# STATEMENT OF EVIDENCE

## AMENDMENT C95 TO THE MILDURA PLANNING SCHEME MILDURA CENTRAL

| Project Code      | MA11810        |

Figure 6 – Overlap of the proposed DDOs

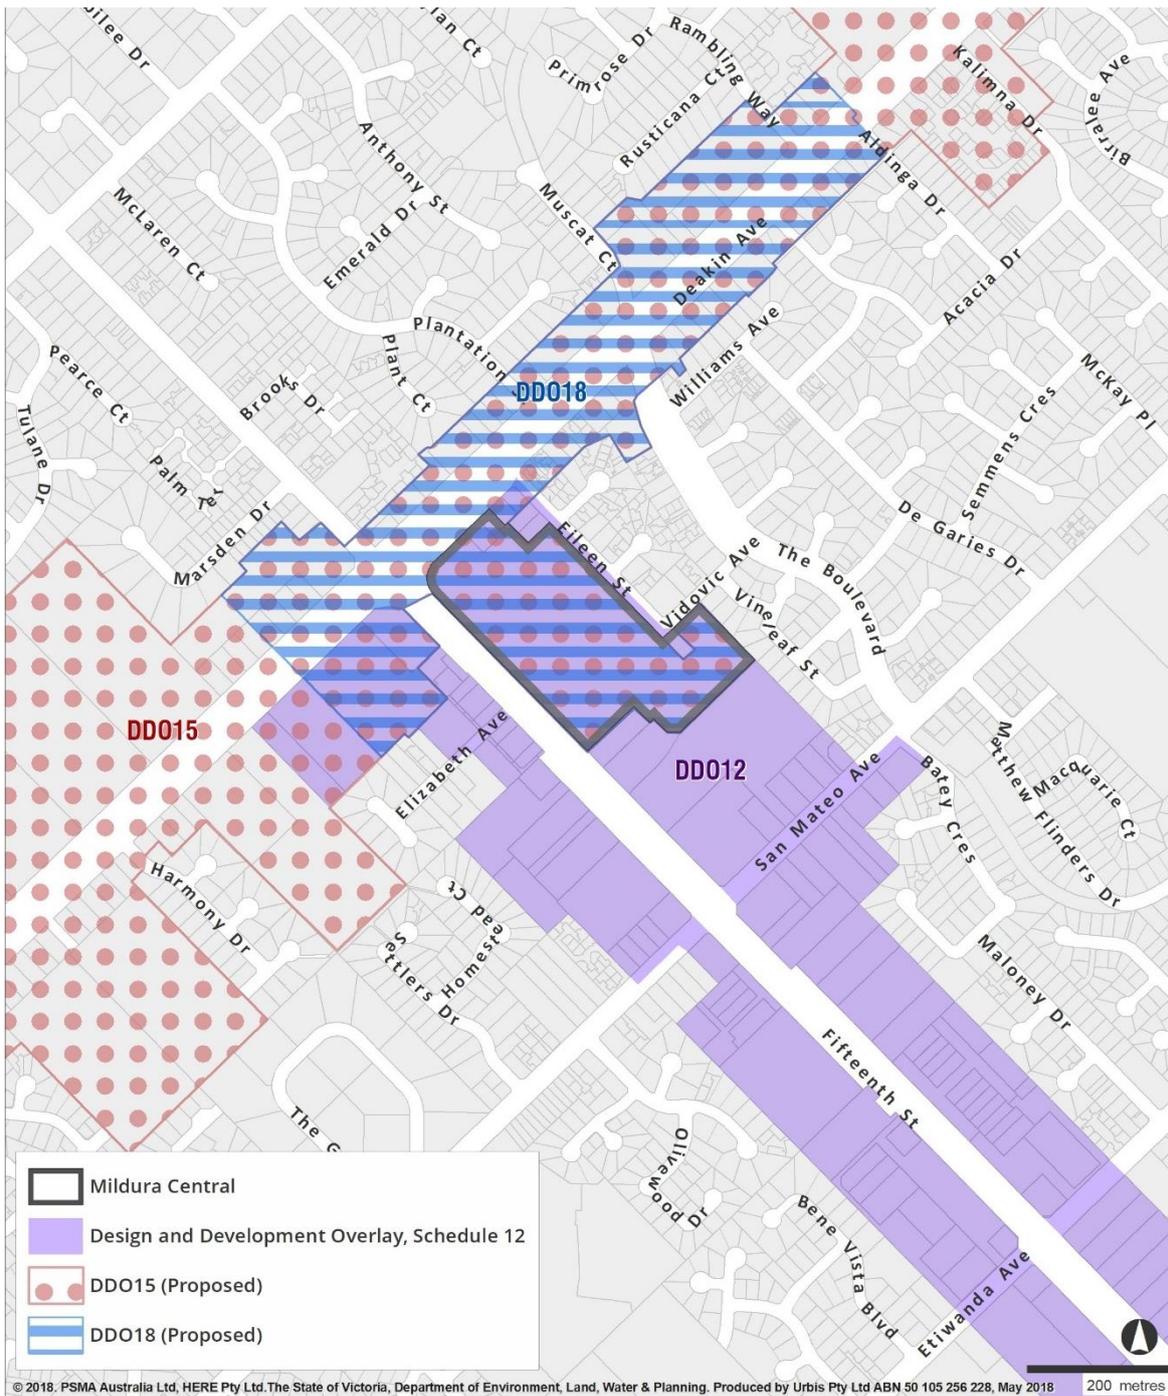
104. There would be three DDOs that would apply to Mildura Central: DDO12, DDO15 and DDO18. Refer to Figure 6 showing the proposed overlap of the three DDOs.

113. If Mildura Central is not removed in its entirety from DDO15 and DDO18, at the very least, the portion of these controls should be reduced, to cover only the land with a direct interface to Deakin Avenue and all aspects that conflict with its role as a key activity centre in Mildura should not apply to this site.
